VSP-15
December 5, 1979

Subject: Garrett AiResearch Manufacturing Company of California
Service Bulletin No. 5-2243 dated November 1, 1979;
"Outflow/Safety Valve - Immediate Inspection for
Broken Diaphragm Retention Ring".

BULLETIN NO. 5-2243

OUTFLOW/SAFETY VALVE - Inspection for broken diaphragm retention ring

Inspection of Typical Outflow/Safety Valve Except Part No. 130406
Figure 1

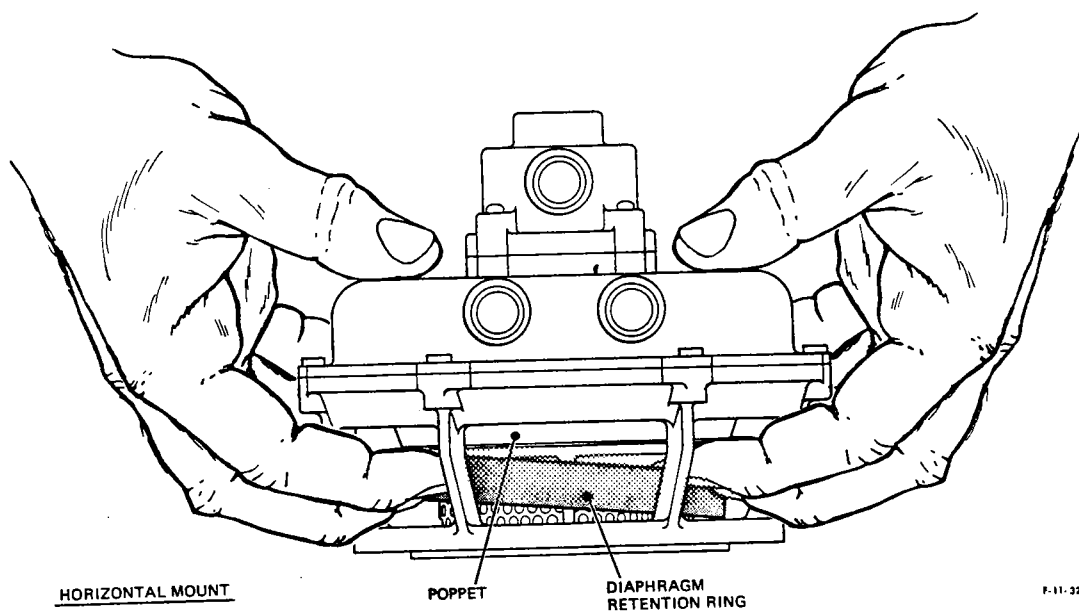
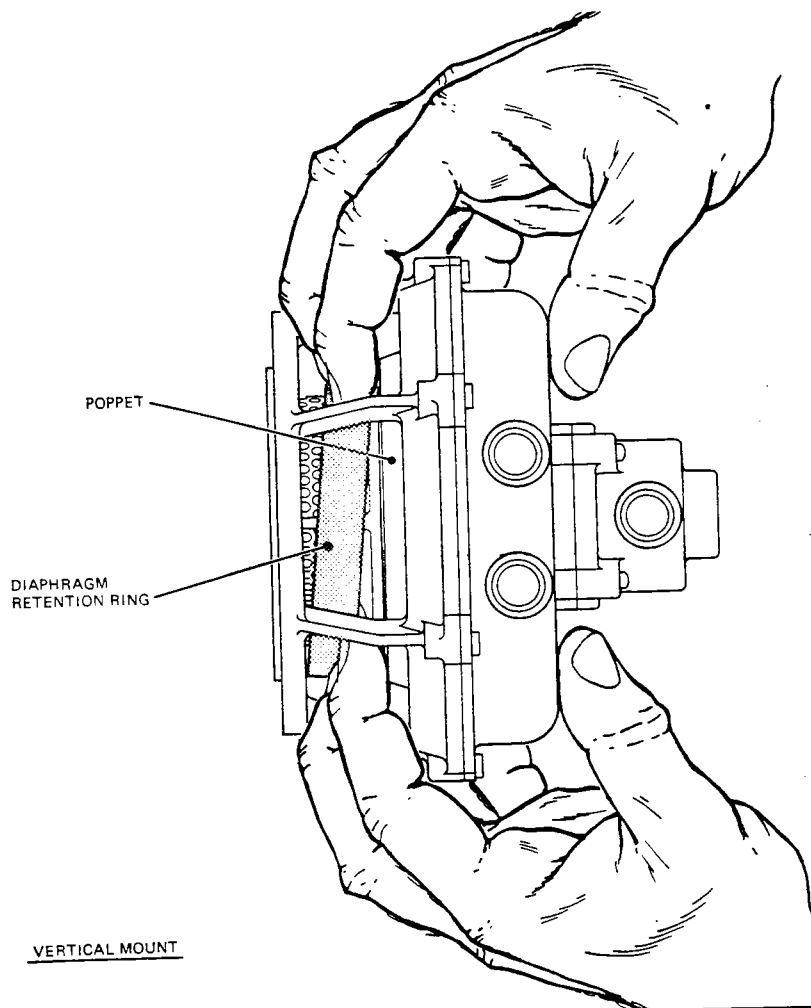
- (1) Inspect all installed (vertical and horizontal mounted) outflow/safety valves, except Part No. 130406, as follows:
 - (a) Carefully raise poppet evenly by grasping with hands about 180 degrees apart as shown in figure 1.
 - (b) Visually check to determine if diaphragm retention ring is displaced from diaphragm support to poppet seating area as shown in figure 1.
 - (c) If diaphragm retention ring is found in poppet seating area, remove and replace outflow/safety valve. Return valve to AiResearch Manufacturing Company of California as specified in Section 1.
- (2) Inspect Outflow/Safety Valves Part, No. 130406 as follows:
 - (a) Remove valve from aircraft as shown in figure 2.

- (d) If diaphragm retention ring is found in poppet seating area, replace outflow/safety valve. Return valve to AiResearch Manufacturing Company of California as specified in Section 1.

Inspection of Typical Outflow/Safety Valve Part No. 130406
Figure 2

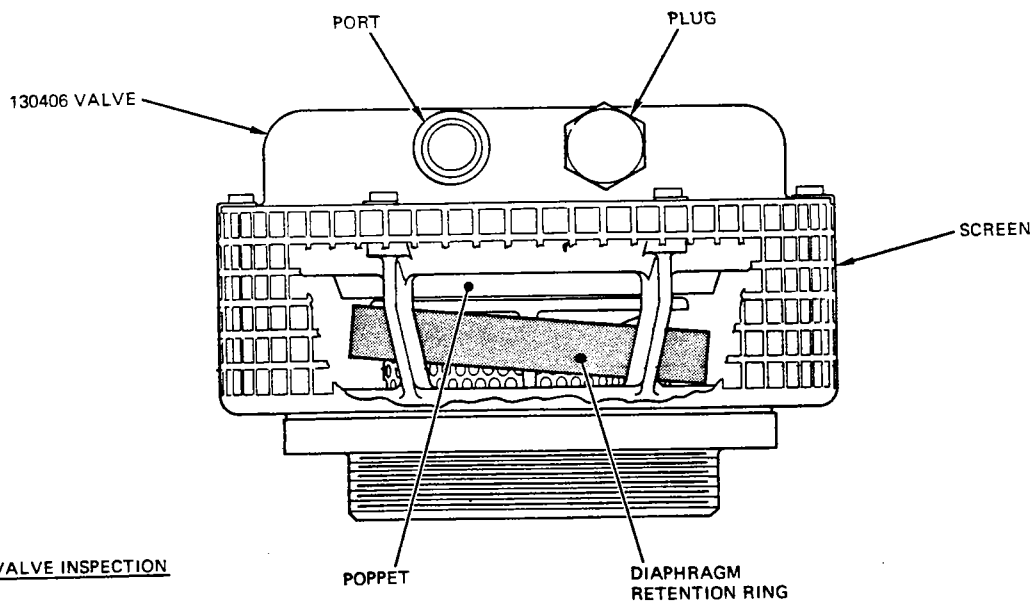
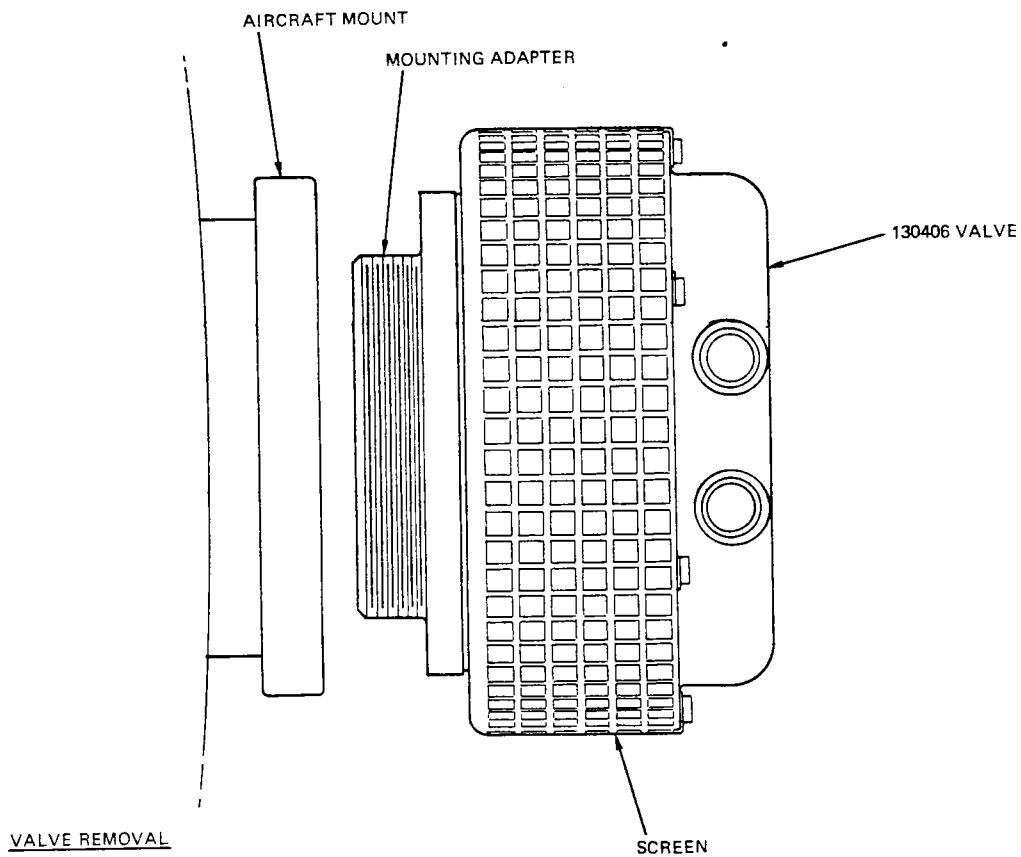
- (b) Install a plug in number "1" or number "2" port and apply a vacuum to opposite port of eight inches water to raise poppet from seat as shown in figure 2.
- (c) Visually check to determine if diaphragm retention ring is displaced from diaphragm support to poppet seating area as shown in figure 2.
